V2500 Propulsion System — Nacelle

International Aero Engines SERVICE BULLETIN

V2500-NAC-78-0128

NACELLE - EXHAUST - COMMON NOZZLE ASSEMBLY, STRUT ATTACH BOLT, - REPLACEMENT OF

CNA Strut Attach Bolt Replacement Figure 1

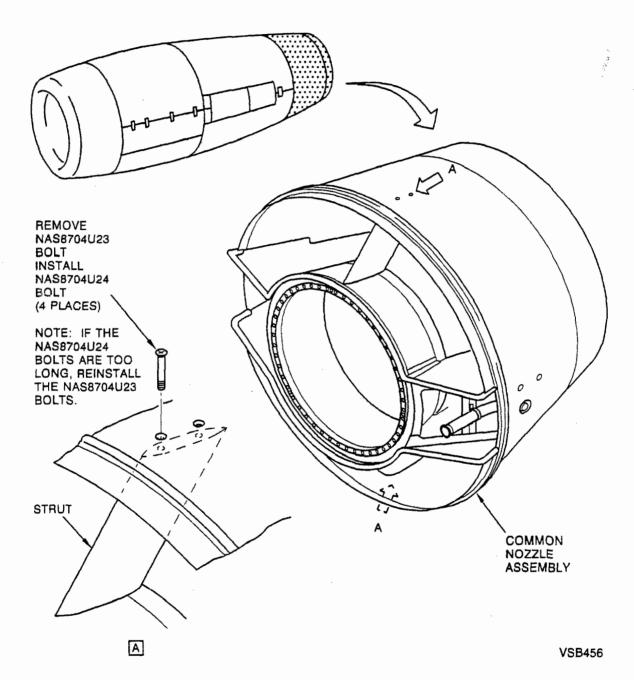
Due to incorrect grip length, the CNA strut attach bolts may loosen and cause damage to the thrust reverser translating sleeve.

The four CNA strut attach bolts, two each at the top and bottom of the CNA are removed and replaced with longer grip length bolts installed with loctite.

- B. Rework or Modification Instructions
 - (1) Remove four NAS8704U23 CNA strut attach bolts from the top and bottom of the CNA. Refer to Figure 1.
 - (2) Apply anaerobic compound sealant (loctite) (CoMat 04-008) to the threads of the four NAS8704U24 bolts.
 - (3) Install the four NAS8704U24 CNA strut attach bolts in the top and bottom of the CNA. Tighten the bolts to a torque of 36-40 inlb (4-4.5 Nm). Refer to Figure 1.

NOTE: If the NAS8704U24 bolts are too long, re-install the NAS8704U23 bolts with the anaerobic compound sealant (loctite) (CoMat 04-008) as instructed in steps (2) and (3).
